Product Change Notification

Date Issued :	May 26, 2022	PCN Number :	512103	
Reason for Change :	Change to Product			
Description of Change :	This notification is to inform you about revision up of the engineering document of the part(s) as identified in the list. This change is for the engineering document only, no changes will be made to the actual products and specification.			
Assessment of Change :	No change to parts - Form/Fit/Function			
Planned Implementation Date :	December 30, 2022			
Sample Availability Date:	May 26, 2022			
Internal Molex Qualification Date :	May 26, 2022			
Last date to request Samples by Cust	omer : May 26, 2022			
Traceability Code Markings / Date :	No special marking on the product or packaging			
Before Picture

PICOLOCK1.5/2.0 APPLICATION TOOLING SPECIFICATIONS

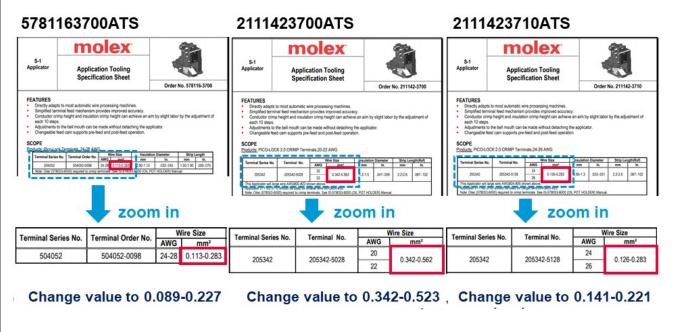
- Change description
 - The Wire size mm² on the Application Tooling Specification will be changed; -5781163700ATS: From 0.113-0.283 to 0.089-0.227 -2111423700ATS: From 0.342-0.562 to 0.342-0.523
 - -2111423710ATS: From 0.126-0.283 to 0.141-0.221
 - The Wire size mm² value corresponding to the AWG value can be calculated by formula. However, since the current value was calculated by the incorrect formula, we will correct the value.
- Product Impact
 - This change affects Application Tooling Specification Document Only
 - No impact to product
- Part Number Impact
 - •504052 series and 205342 series
 - ·see attached impacted parts list for detail
- · How the change implement: Drawing revision update
